## Product Change Notification: ALAN-15VWL0673

CCB 6825 Final Notice: Qualification of MMT as an additional assembly site for selected PIC24FJ128Gxx, PIC24FJ256Gxx, PIC24FJ32Gxx, PIC24FJ512Gxx, PIC24FJ64Gxx, and PIC32MM0xx device families available in 48L UQFN (6x6x0.6mm) package.

### PCN# ALAN-15VWLO673

## ANAC

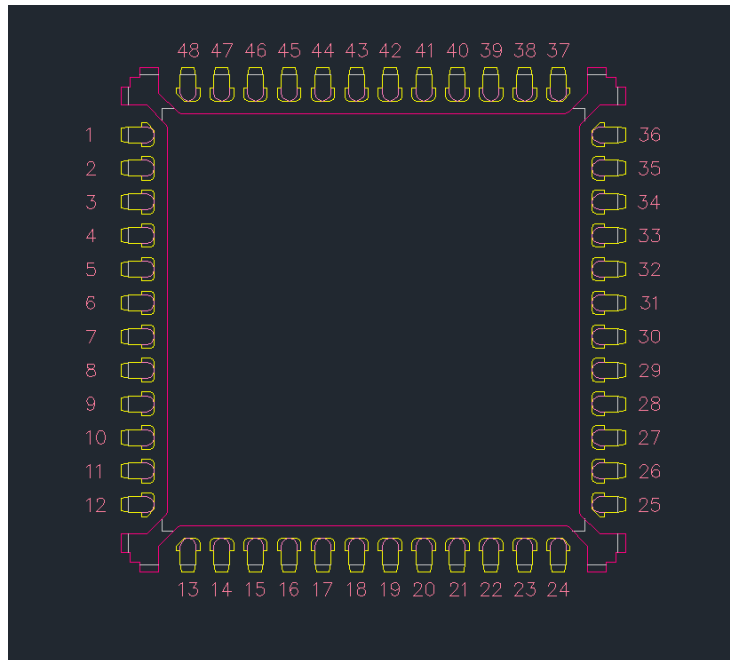
Lead-Frame Material	C7025
Lead Lock	No
DAP Surface Prep	Bare Cu

## MMT

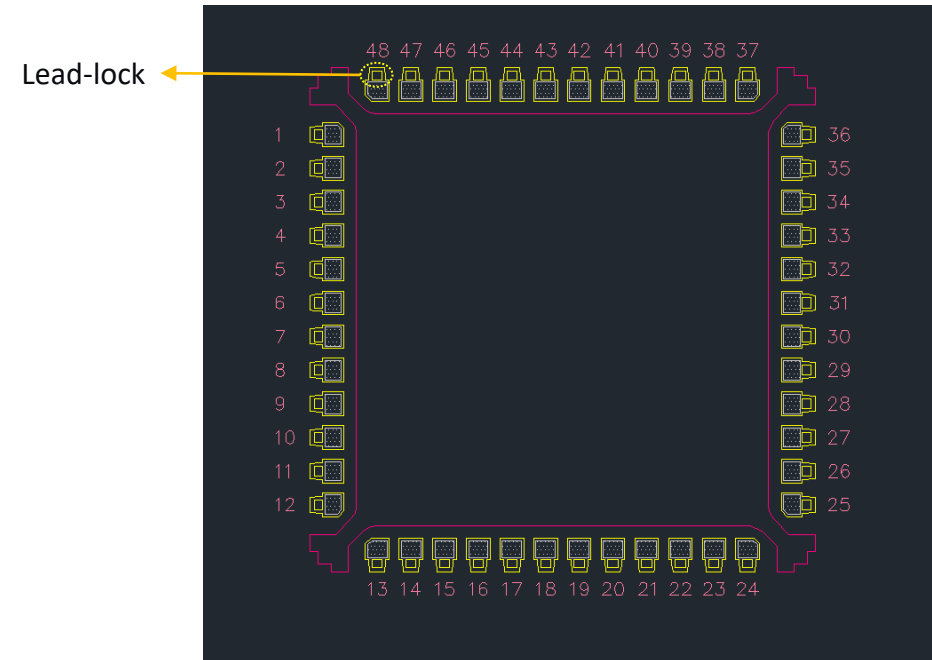
Lead-Frame Material	EFTEC64T
Lead Lock	Yes
DAP Surface Prep	Cu-RT
